TO: Mercedes-Benz Dealer Principals, General Managers, Sales Managers, Service Managers, Parts Managers	FROM: Heike Scheuble, General Manager, Aftersales	
RE: Recall Campaign Launch Notification MY16-17 447 (Metris) Fuel Line M274	DATE: January 18, 2019

Recall Campaign Bulletin

Campaign No. 2019010002, January 2019

SUBJECT: Model 447 (Metris), Model Years 2016 - 2017 Mercedes-Benz Fuel Line M274

S47.25-A001-09

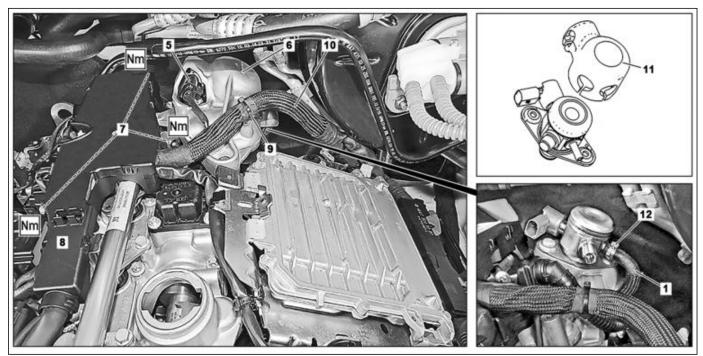
- 1 Fuel hose
- 2 Lower click clamp

- 3 Fuel hose to fuel line of service connection
- 4 Click clamps

- 7 Bolts
- 5 Electrical connector
- Shielding 6
- Cable duct 8
- 9
 - Cable tie with retaining clip
- Electrical wiring harness 10
- Soundproofing 11
- Upper click clamp 12

6	Check fuel hose to fuel line of service connection (3) in area of click clamps (4) for damage and fuel coating.	If there are no problems with the fuel hose to the fuel line of the service connection (3), ↓ Continue with operation step 8. If the fuel hose to the fuel line of the service connection (3) is coated with fuel or damaged, ↓ Proceed with step 7.

7	Replace fuel hose to fuel line of	Only if the fuel hose to the fuel line	
	service connection (3) and click clamps (4).	of the service connection (3) is coated with fuel or damaged.	
		i	
		Collect escaping fuel in a suitable container and seal connections.	
		i	
		Dispose of replaced components correctly. To do so, observe the	
		applicable legal requirements and	
		specifications of the relevant country.	
		Pliers for click clamps	171 589 00 37 00
		S Record plug	129 589 00 91 00
8	Lower vehicle to working height.		
9	Remove cover of cylinder head cover.		
			AR01.20-S-5015EG
10	Detach electrical connector (5) from shielding (6).		
11	Remove screws (7) of cable duct (8).	i The cable duct (8) remains attached.	
12	Detach cable tie with retaining clip (9) of electrical wiring harness (10) from shielding (6).		
13	Remove screws of shielding (6) in reverse order from tightening procedure.		
	Tightening procedure for high- pressure pump shielding		AR07.02-S-0815-01EG

14	Remove shielding (6).		
15	Remove soundproofing (11).		
16	Replace fuel hose (1) and upper click clamp (12).	i Collect escaping fuel in a suitable container and seal connections. i	
		Dispose of replaced components correctly. To do so, observe the applicable legal requirements and specifications of the relevant country.	
		Pliers for click clamps	171 589 00 37 00
		S Record plug	129 589 00 91 00
Install	· · ·	•	
17	Install soundproofing (11).		
18	Install shielding (6).
